TECHNICAL NOTE TN-1137-SR

TM9155, TP9155, TP9160 Subscriber Unit Firmware Upgrade to v2.04.00.0002

22nd December 2005

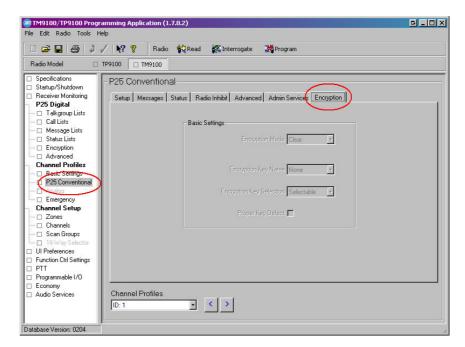
DES (**D**igital **E**ncryption **S**tandard) Encryption has been added in this release. This form of encryption uses a 64 bit/8 octet (16 Hex digit)) "key variable" that is loaded into the radio via a KVL3000+ Keyloader in conjunction with a Tait adaptor (TPA-SV-020). Once loaded into the radio it is not possible to read the key variable(s) back out.

There are two areas in the XPA that deals with Encryption. The first is the Encryption page.
